COVER LETTER

RE: FCC Class 2 Permissive Change
FCC ID: QOQWT41E
IC: 5123A-BGTWT12

Figure 1: Original WT12

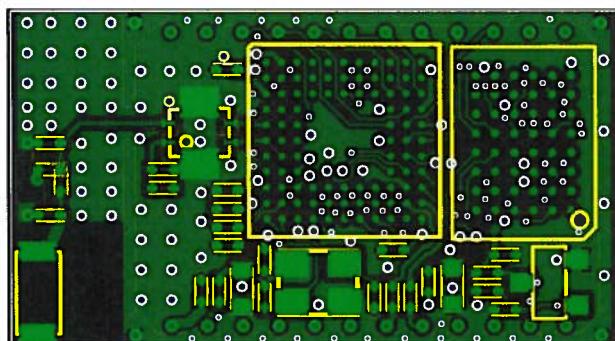
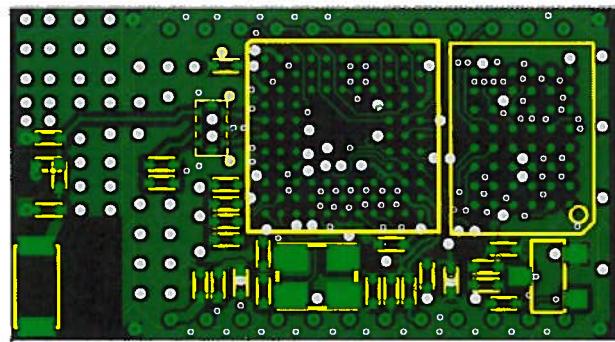
Bluegiga Technologies Oy / Bluetooth module, FCC ID: QOQWT12 and IC: 5123A-BGTWT12 would like to have your authorization for a Class 2 Permissive Change. The C2PC is to make a HW change to update the balun to a one with smaller package but with similar characteristics as with the original version. Test report is provided to show that the RF characteristics have not changed. The change is shown in the layout pictures below.

Figure 2: WT12 after the C2PC
